CITY OF ST. HELENS PLANNING DEPARTMENT

LAND USE FILE BRIEF

TO: Planning Commission
FROM: Jacob A. Graichen, AICP, City Planner
FILE: Conditional Use Permit **CUP.1.24**, Unlisted Use **U.1.24**, and Access Variance **VAR.7.24**
CCMH Gable Road Campus Expansion
DATE: September 30, 2024

**CITY OF ST. HELENS PLANNING DEPARTMENT
STAFF REPORT**

MEMORANDUM

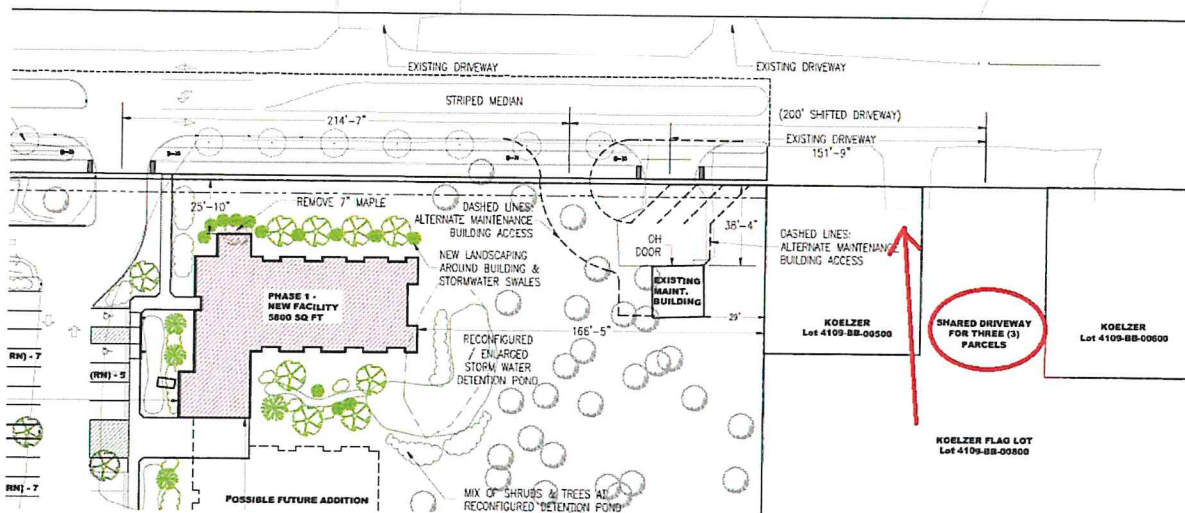
The plans and narrative provided for this application note a driveway separation of 151'9" between the "CCMH shop driveway," the subject of Access Variance VAR.7.24, and the closest driveway to the east.

Noteworthy, the plans also depict a driveway that is closer at approximately 110 feet. This closer driveway is identified on the existing conditions too. This memo is intended to help you understand this discrepancy.

Below: An excerpt of the site plan provided with this application. The driveway (also identified on the existing conditions) is shown here as identified by the red arrow but not acknowledged by the applicant. Though recent physical changes have occurred, they are not necessarily legal changes. The notation on the plans circled in red is relevant to this.

Because of this illegitimacy of the circumstances as of the date of this memo, staff is not comfortable basing a driveway distance on this. The planning commission must use the 110' distance unless better evidence of legitimacy is provided.

Above: Street view of the taxlots 500, 600 and 800 as shown above, also known as 2145 and 2155 Gable Road in late 2018. Note the individual driveways to each dwelling and lack of central drive. Also note the woodlands in the background.

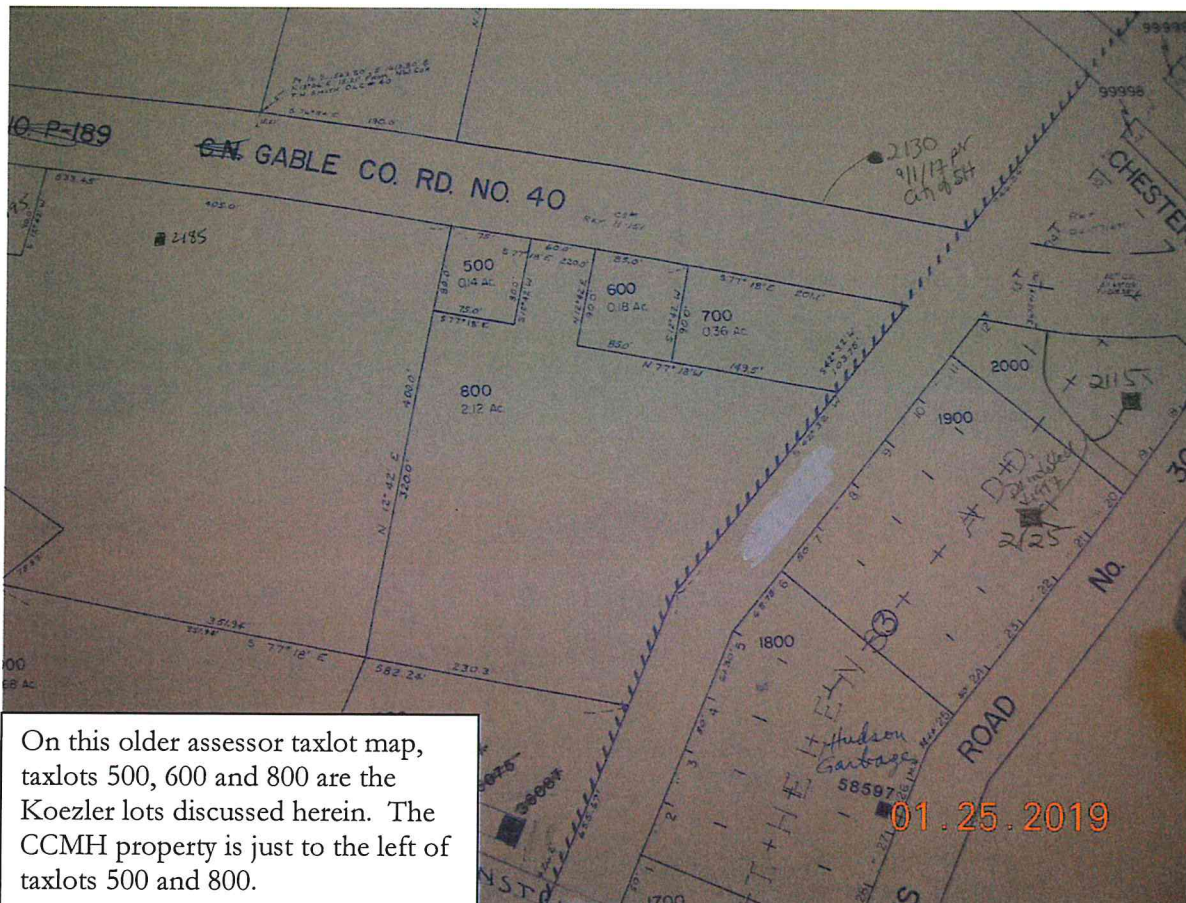
Despite no land use decision, Erik still implemented, at least physically, a shared access. This is after several years since our discussion mentioned above, so great credit to him. However, there is no record requiring this and nothing has been provided that the three parcels are legally bound to use a sole shared access. Moreover, this "shared access" constitutes improvements in the Gable Road right-of-way without any permit for work in the right-of-way from the City of St. Helens. Gable Road is a city jurisdiction road.

Based on staff research, each parcel appears to have been created a long enough time ago that they would be considered legal lots of record. Thus, there is little preventing the three parcels to be owned by three separate entities who may not want a shared drive and want to go back to individual drives.
